PROPOSED TECHNICAL SPECIFICATION

Marked-up Technical Specification Table 4.4-5

REACTOR VESSEL MATERIAL SURVEILLANCE PROGRAM - WITHDRAWAL SCHEDULE

SAFETY EVALUATION

FIGURE 1. ARRANGEMENT OF SURVEILLANCE CAPSULES IN THE TURKEY POINT UNITS 3 and 4 PRESSURE VESSELS

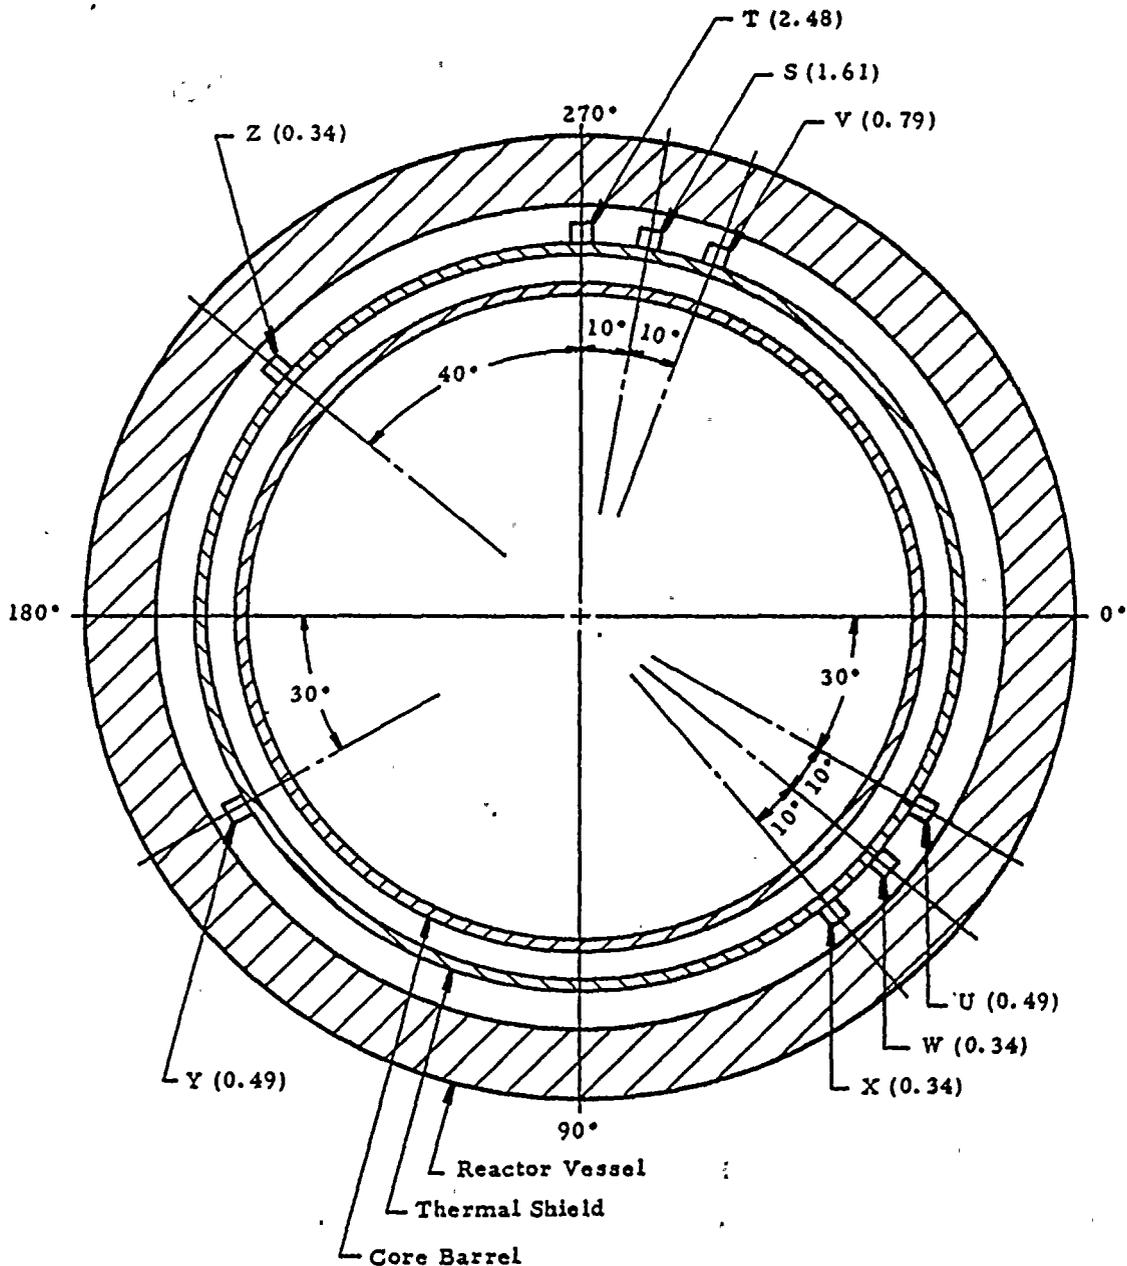
This proposed amendment revises Technical Specification Table 4.4-5 to allow FPL to move surveillance capsule X from the 50' vessel location to the 270' vessel location. This capsule move is requested in order to place it in a higher flux position.

The X capsule currently has a "lead" factor of 0.34 based on its placement in the Unit 3 and 4 reactor vessels (see figure 1). The lead factor is determined by the ratio of the neutron fluence at the surveillance capsule to the neutron fluence at the reactor vessel inside surface. The 270' vessel position, formerly occupied by capsule T (removed from the Unit 3 and 4 reactor vessels in 1974 and 1975, respectively), has a lead factor of 2.48. By moving surveillance capsule X to the surveillance capsule T position, it would accumulate fluence at a much greater rate than the reactor vessel.

The placement of surveillance capsule X in a higher flux position would enhance our capabilities to predict the end of life reactor vessel properties, and conform to the recommendations of ASTM E 185-82 regarding accumulated neutron fluence for an end of life capsule. Capsule X is scheduled to be removed from the Unit 3 reactor vessel after 33 years of operation. The Unit 4 capsule X is a standby capsule.
